APPLICATION FOR APPEAL

Attachment to Application for Appeal for 83 Cook Avenue W (10/11/2010)

What is being appealed? Fire C of O: Only Egress Windows

FIRE INSPECTION CORRECTION NOTICE

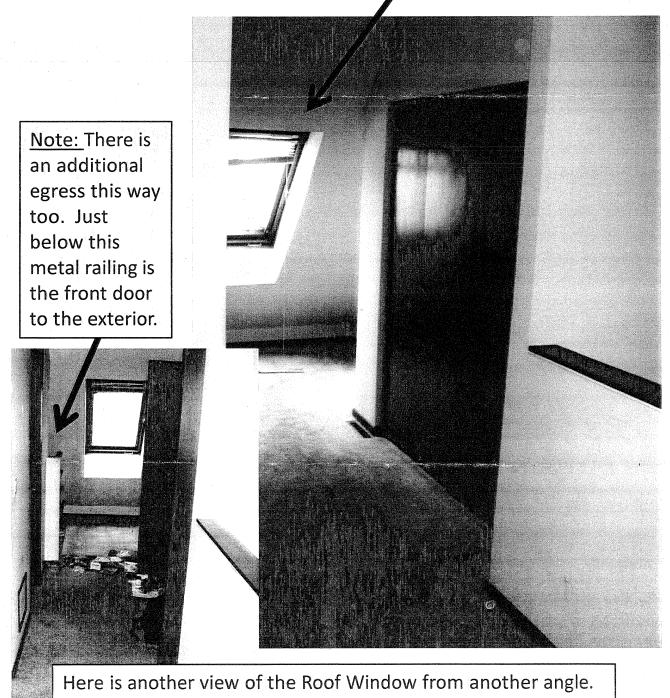
Summary: Inspector states window is only 21" high x 24" wide, but the window is much larger than this. It opens to approximately 42" high x 24" Wide. (Stated minimum code is 24" high x 20" wide.) Also, the pre-existing structure does not allow for reasonable modification of the existing egress.

Detail: The existing egress window is a Velux "Roof Window" which was designed for locations that require egress. It was engineered for scenarios such as this property, where the steep, pitched roof serves as the only exterior wall for the bedroom in question. Please see attached 4 pages of photos.

This is the window in question 83 Cook Ave. W.

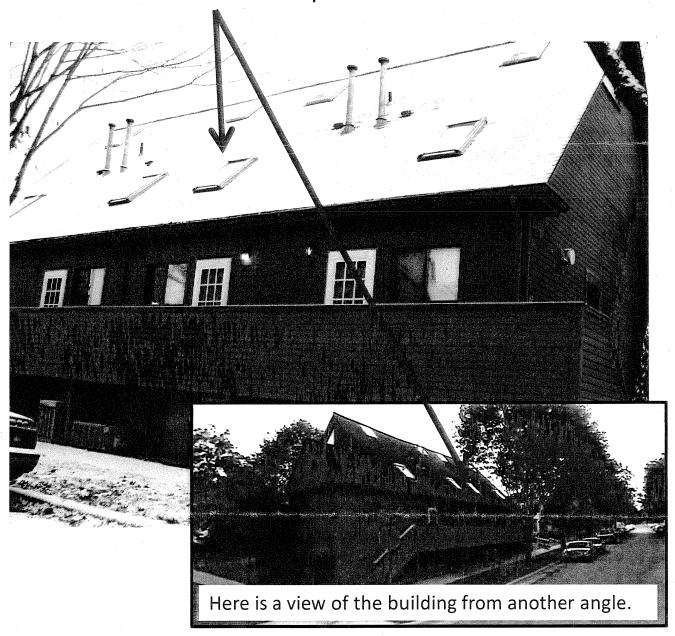
This is the window in question as it is seen from the *interior* of 83 Cook Ave. W. It is a Velux Roof Window.

This photo shows the Velux egress window's compound-hinge design at work.

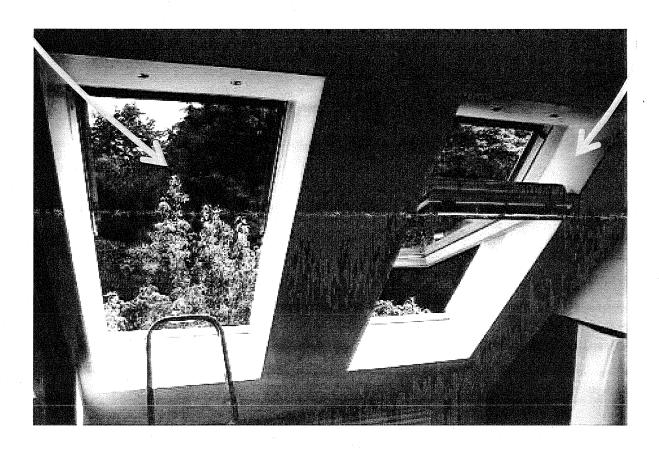
- The window on the *left* is a window opening as a door might open to a full, 90-degree position. The glass is out of view on the very left side of the opening.
- The window on the *right*, shows the hinge mechanism operating in a 'butterfly' mode. It can open much more than this to nearly 360 degrees. This window in this example is open perhaps only 30-35 degrees.
